STATE OF WASHINGTON
STATE BUILDING CODE COUNCIL

Title: Appendix XX: Single Exit Provisions for Multifamily up to 6 stories
(e.g: Footings for wood foundations)

Proponent: Washington State Building Code Council
Title: Single Exit Multiplex Housing TAG
Date: November 4, 2025

Figure XX102.2 – Single Exit Stairway Serving 5 stories of R-2 Apartments in a 6-story Building

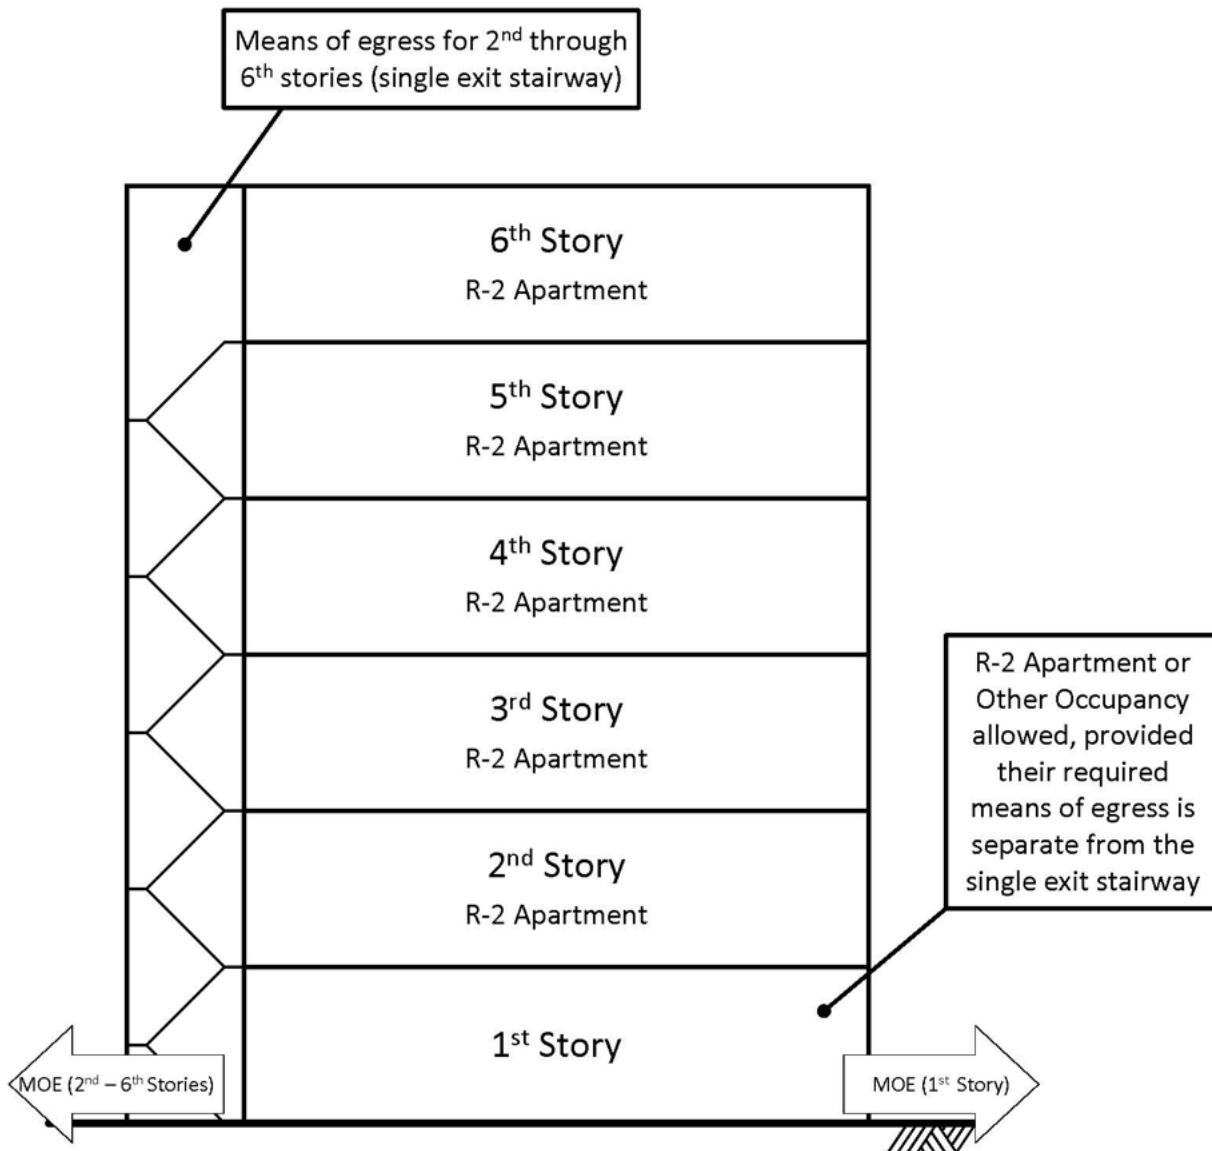
XX102.2 Single exit in Group R-2 apartment houses. In addition to the *means of egress* requirements of Chapter 10, not more than 5 stories of Group R-2 Apartment Houses are permitted to be served by a single exit under the following conditions:

1. The building has not more than six stories above grade plane.
2. **USER NOTE:** The 5-story limitation in Section XX102.2 does not prohibit an R-2 apartment occupancy from being located on the first story of a 6-story building. For a 6-story building with a single exit stairway, R-2 apartments or other occupancies are permitted on the first story (subject to other requirements in this code), provided that the required means of egress for the occupancies on the first story are separate from the single exit stairway. See Figure XX102.2. Other occupancies are permitted in the same building provided they comply with all the requirements of this code. Other occupancies shall not directly communicate with the Group R-2 occupancy portion of the building or with the single-exit stairway.

12. A minimum ½ hr fire-resistance rated corridor shall separate each dwelling unit entry/exit door from the door to an interior exit stairway, including any related exit passageway, on each floor. Dwelling unit doors shall not open directly into an interior exit stairway. Dwelling unit doors are permitted to open directly into an exterior exit stairway.

13. There shall be no more than 20 feet (6096 mm) of travel to the exit stairway from the entry/exit door of any dwelling unit.
 14. Exit access travel distance measured in accordance with Section 1017 shall not exceed 125 feet.

15. An exterior exit stairway or interior exit stairway shall be provided. The interior exit stairway, including any related exit passageway, shall be pressurized in accordance with Section 909.6.3 and Section 909.20. Doors in the stairway shall swing into the interior exit stairway regardless of the occupant load served. Doors from the interior exit stairway to the building exterior shall swing in the direction of exit travel. Stairway shaft pressurization equipment shall be connected to legally required standby power per Section 909.21.5. For the purposes of this section, legally required standby power shall comply with 2023 NEC Section 701.12, options (D), (E), (F) or (H) or subsequent revised section number(s).
